UNITED STATES PATENT AND TRADEMARK OFFICE

APPLICATION NO.	FILING DATE	FIRST NAMED INVENTOR	ATTORNEY DOCKET NO.	CONFIRMATION NO.
10/689,001	10/20/2003	Gayatri Vyas	8540G-236COA	4101
27572	7590	10/30/2008	EXAMINER	
HARNESS, DICKEY & PIERCE, P.L.C.			ALEJANDRO, RAYMOND	
P.O. BOX 828			ART UNIT	PAPER NUMBER
BLOOMFIELD HILLS, MI 48303			1795	
MAIL DATE		DELIVERY MODE		
10/30/2008		PAPER

Office Action Summary	Application No.	Applicant(s)	
	10/689,001	VYAS ET AL.	
	Examiner	Art Unit	
	Raymond Alejandro	1795

DETAILED ACTION

FIG. 2

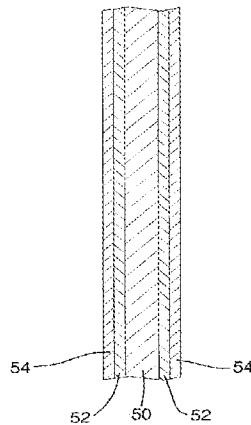
Disclosure B: Li et al also disclose and illustrates bipolar septum/plate 8 or end contact elements 14 and 16 comprising a core 50 of a metal such as Al or Ti; a barrier/protective layer 52 of a metal which forms a passivating oxide film being deposited on the core 50, and is cover with a topcoat of Ti-nitride 54 (COL 3, lines 17-33). More importantly, disclosed therein is that the Ti-nitride topcoat is a micro-discontinuous coat having a plurality of defects therein exposing said protective coating to a corrosive operating environment (CLAIM 1 & CLAIM 3)

As further evident from **Disclosure B** above, the micro-discontinuous Ti-nitride topcoat has a plurality of defects therein exposing the barrier/protective metal layer 52 to the electrodes.

Thus, one way or another, Disclosure A or Disclosure B, alone or in combination, fully support having a non-ferrous metal-oxide coating in direct contact with the gaseous reactants and the electrode part of the membrane electrode assembly.

FIG. 1

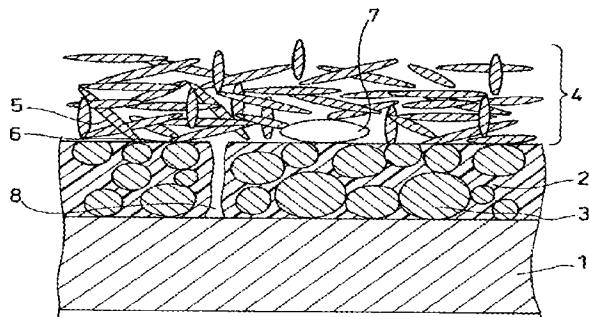
1st approach: it is imperative to note that the electroconductive resin layer incorporates therein an electroconductive particulate substance (COL 4, lines 5-15) and powders of metal oxide such as Ru-oxide are effective as the electroconductive particulate substance (COL 4, lines

15-21). As depicted in **Figure 1** below, electro-conductive particles 3 are dispersed in the electroconductive resin layer 2 and direct contact gas diffusion electrode 4 (See Figure 1/ COL 6, lines 12-30). *Thus, Ru-metal oxide particles directly contact the electrode 4.*

FIG. 1

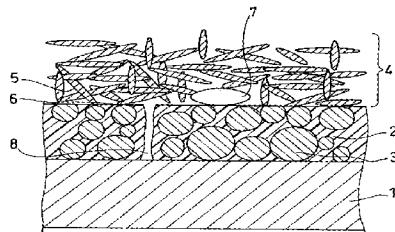
1st approach: in this respect, (*emphasis supplied*→) it is imperative to note that electroconductive resin layer 2 incorporates therein an electroconductive particulate substance

(COL 4, lines 5-15) and powders of metal oxide such as Ru-oxide are effective as the electroconductive particulate substance (COL 4, lines 15-21). As depicted in **Figure 1** below, electro-conductive particles 3 are dispersed in the electroconductive resin layer 2 and direct contact gas diffusion electrode 4 (See Figure 1/Col 6, lines 12-30). *Thus, Ru-metal oxide particles directly contact the electrode 4.*

2nd approach: In addition to that, applicant has articulated that the reference “fails to teach a metal oxide coating in communication with a reactant gas”. Interestingly, applicant has admitted that “*The oxide layer, being sandwiched between the substrate and the resin layer, prevents contact between the oxide layer and the reactant gas*” (See amendment dated 11/03/06 at page 16, last sentence of 2nd full paragraph). This applicant’s statement or admission contributes to the position taken by the examiner because the oxide is formed on the surface of the metal substrate 1 facing the gas diffusion electrode 4. Accordingly, reactant gas diffuses through pinhole 8 in the resin layer 2 and contacts the oxide layer deposited between the resin layer 2 and the metal substrate 1. Since the oxide layer prevents contact between the reactant gas and the metal substrate, it can be said that the oxide layer is acting as a direct barrier therebetween. Meanwhile, the oxide layer per se is in direct contact with the reactant gas, and therefore in communication therewith.

Stated alternatively, Gyoten et al teach that the oxide layer is situated between the metal substrate 1 and said electroconductive resin layer 2 (COL 8, lines 48-52/CLAIM 2). Notice also the presence of pin-hole 8 and gas diffusion electrode 4 (See FIGURE 1/COL 6, lines 12-30). Given that pin-hole 8 directly provides an open path therebetween, it can be said that reactant gas diffusing through gas diffusion electrode also diffuses through the electroconductive resin layer 2. Therefore, said reactant gas contacts or communicates with the oxide layer placed between the metal substrate 1 and said electroconductive resin layer 2.
